**IN THE MATTER OF** Proposed Plan Change E: Roxburgh Residential  
Area to the Palmerston North City Council  
District Plan

**SUPPLEMENTARY STATEMENT OF EVIDENCE OF EAMON MICHAEL GUTHRIE AND ANDREA  
MICHELLE HARRIS ON BEHALF OF PALMERSTON NORTH CITY COUNCIL**

**Dated: 25 JUNE 2025**

<https://www.timeanddate.com/sun/@-40.36221,175.64531?month=6&year=2025>

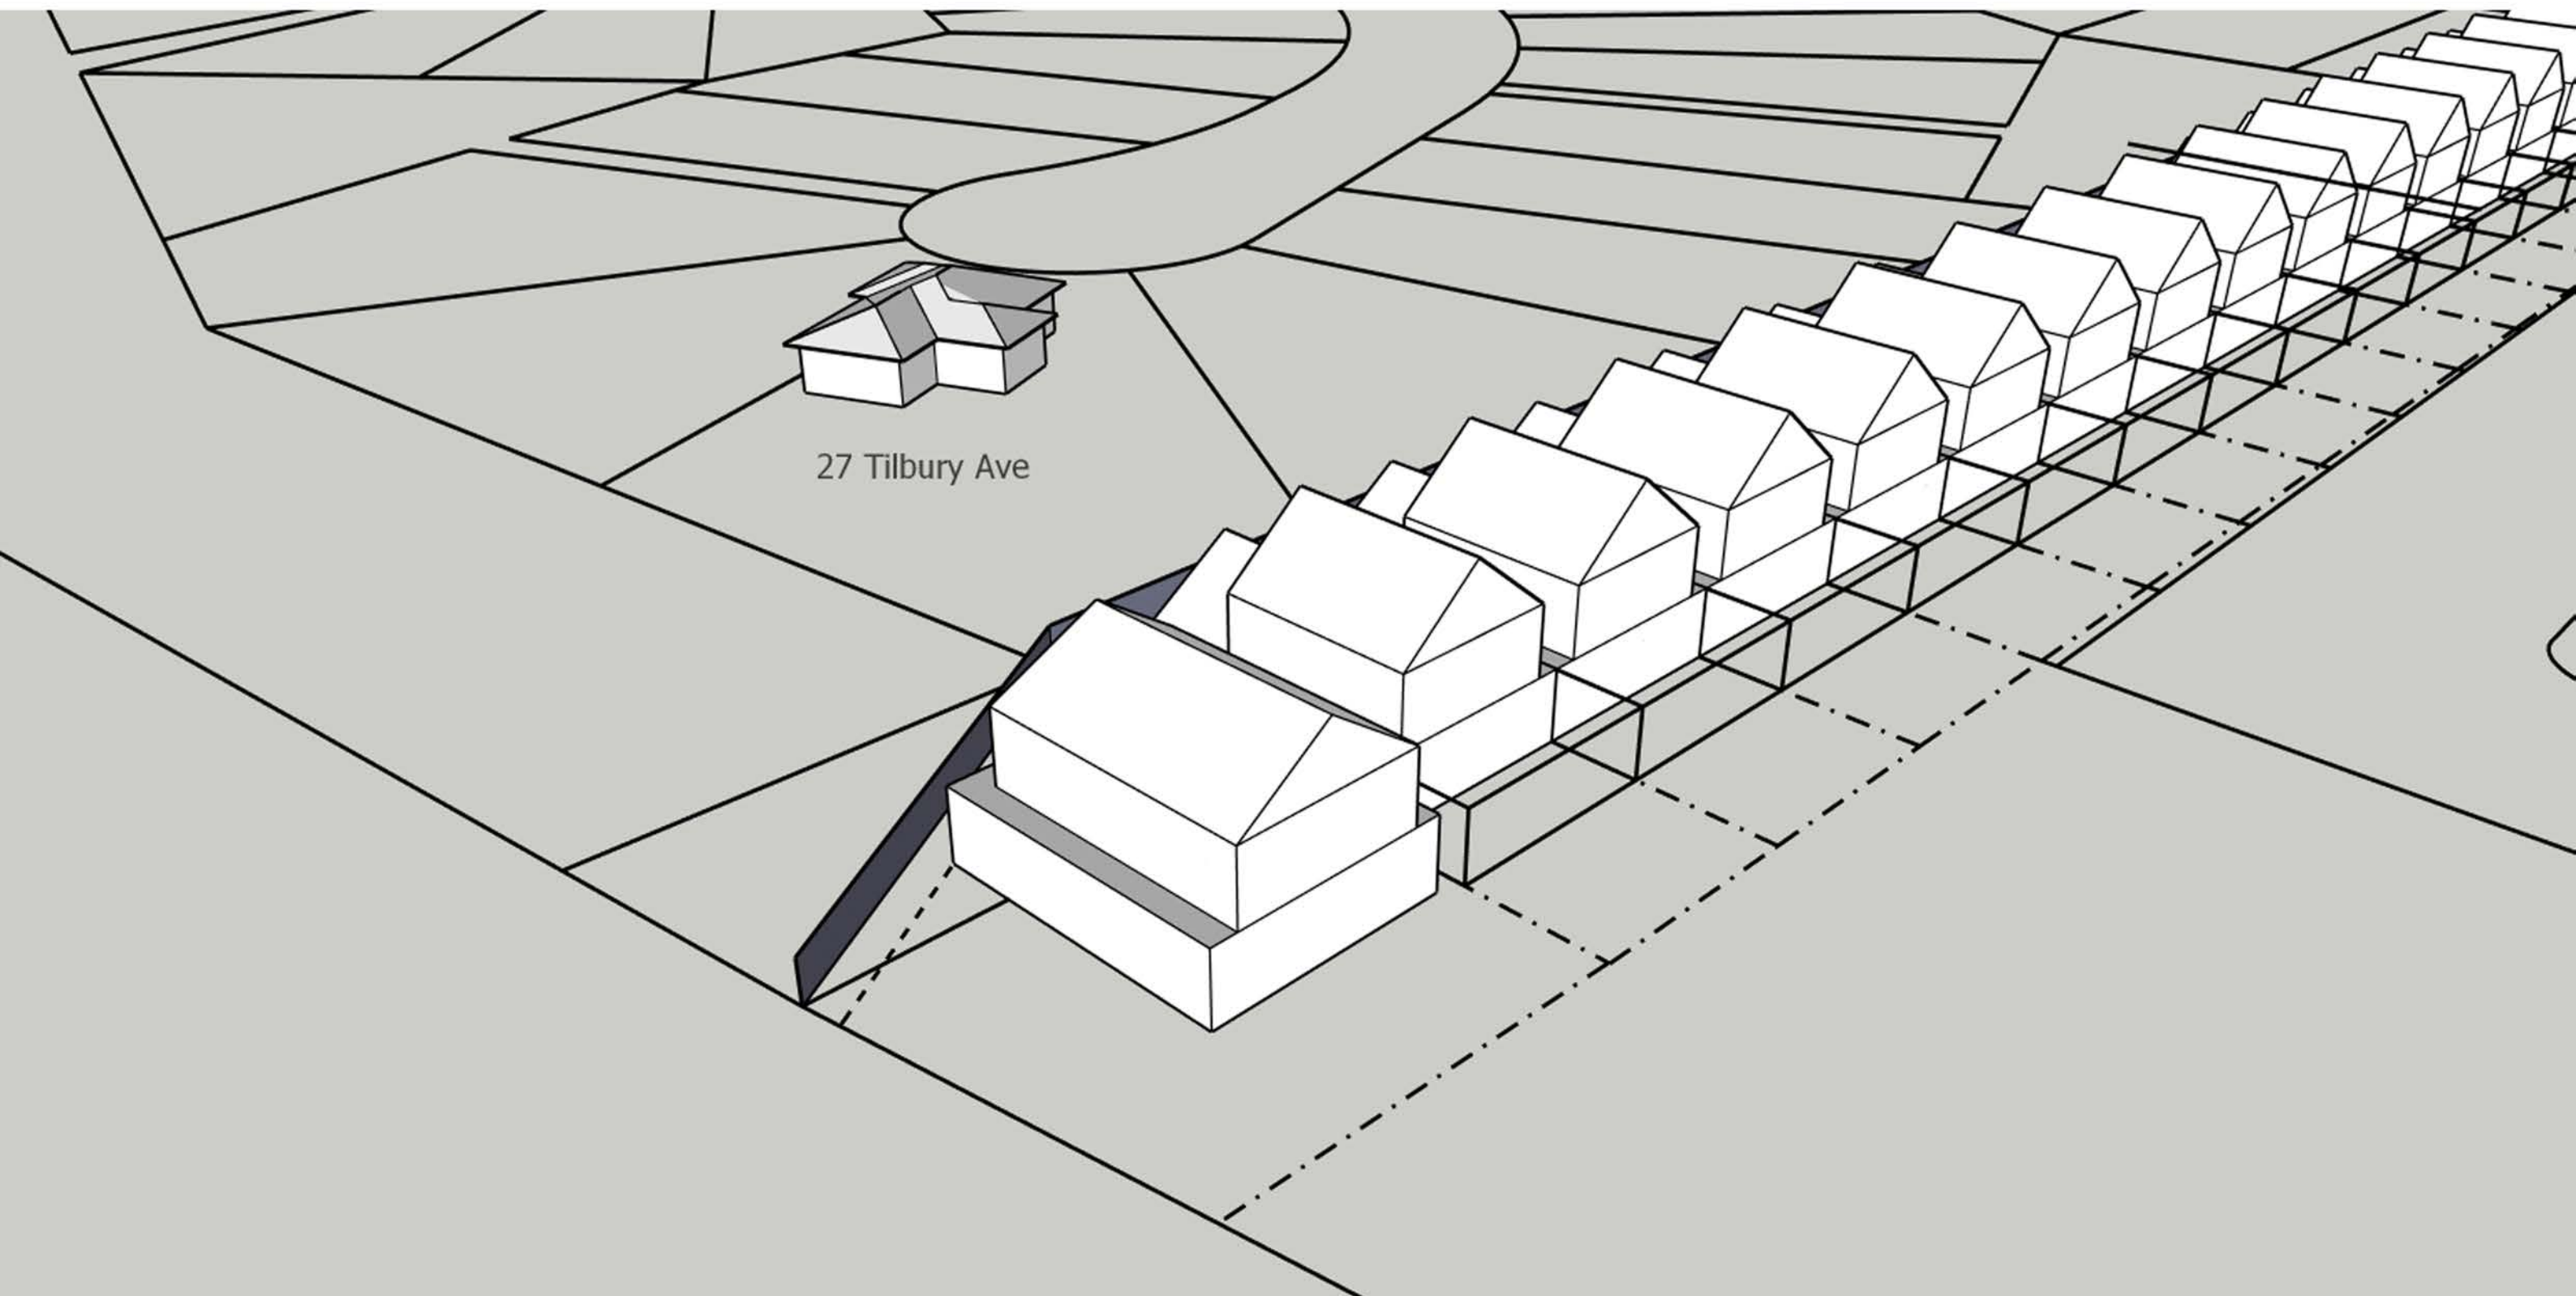
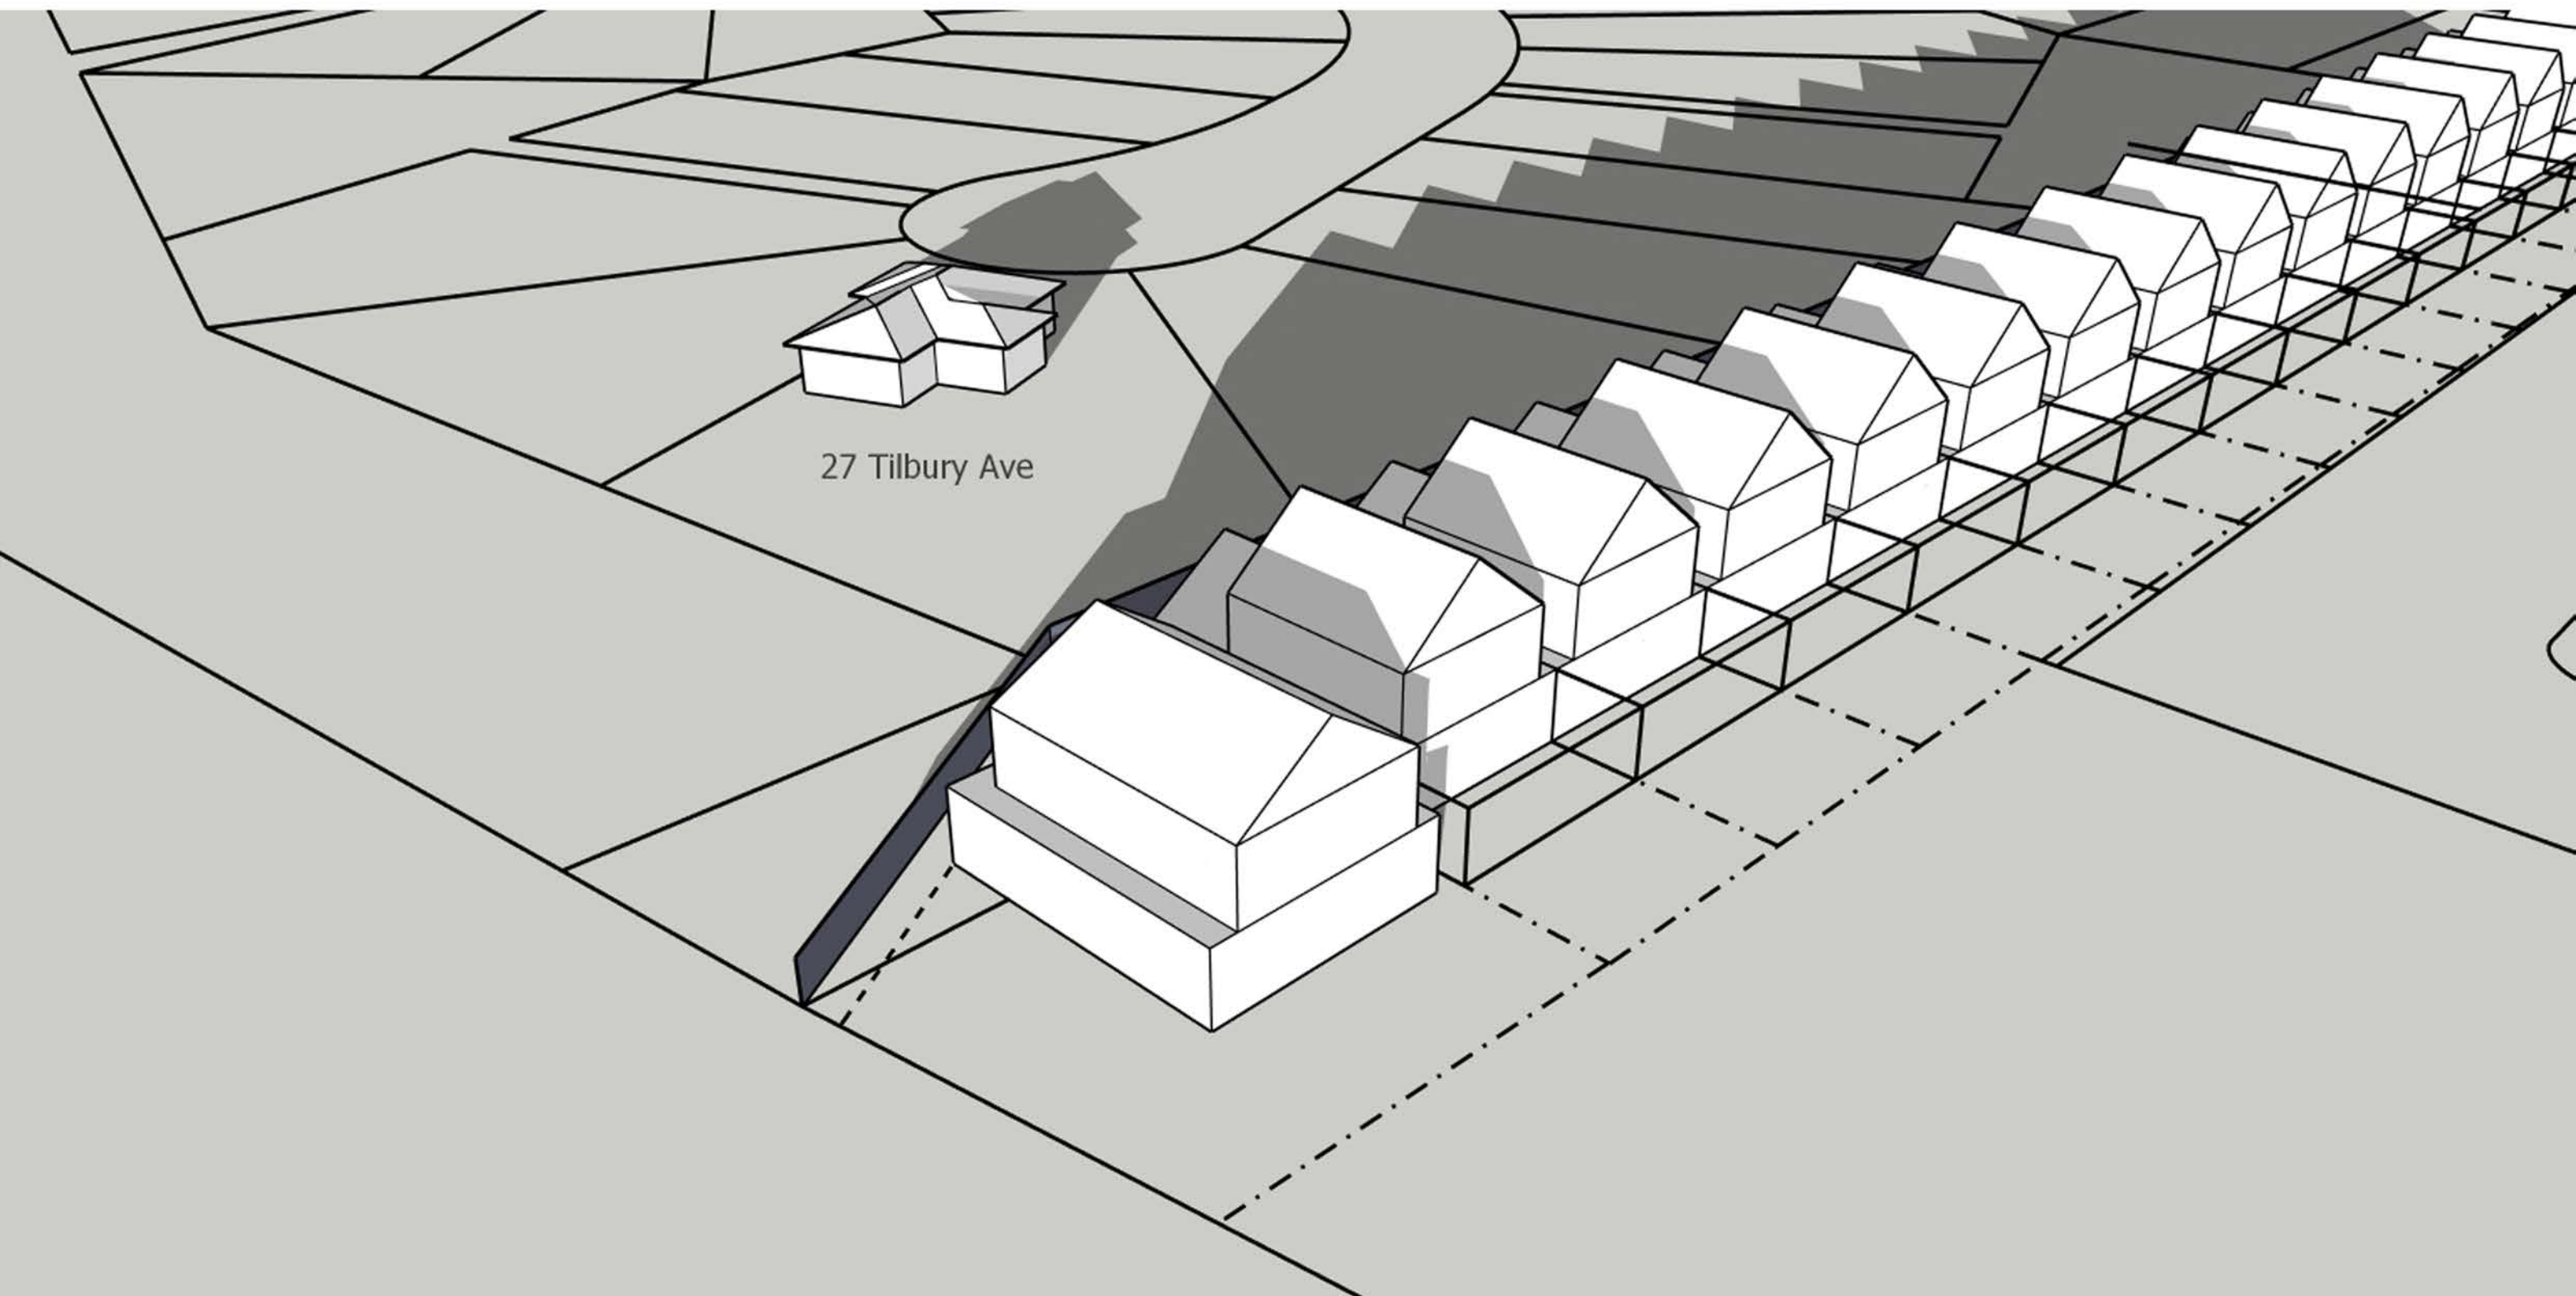
[43] In support of this approach, attached at **Attachment B**, are updated renders showing the potential shading effects on Tilbury Avenue, as a result of the revised performance standard. These have been prepared by Mr Charnley and are based on what the shading and building bulk effects may be during winter solstice along the Tilbury Avenue boundary.

[44] We consider that a separation distance of 1.5m plus a single-storey height limit within rear third of a lot is appropriate. The revised performance standard will provide a reasonable degree of privacy and bulk protections along the Tilbury Avenue interface, as was sought originally from Ms Watson. Figure 1 in the Residential zone shows a height recession plan already taking into account the elements of the proposed
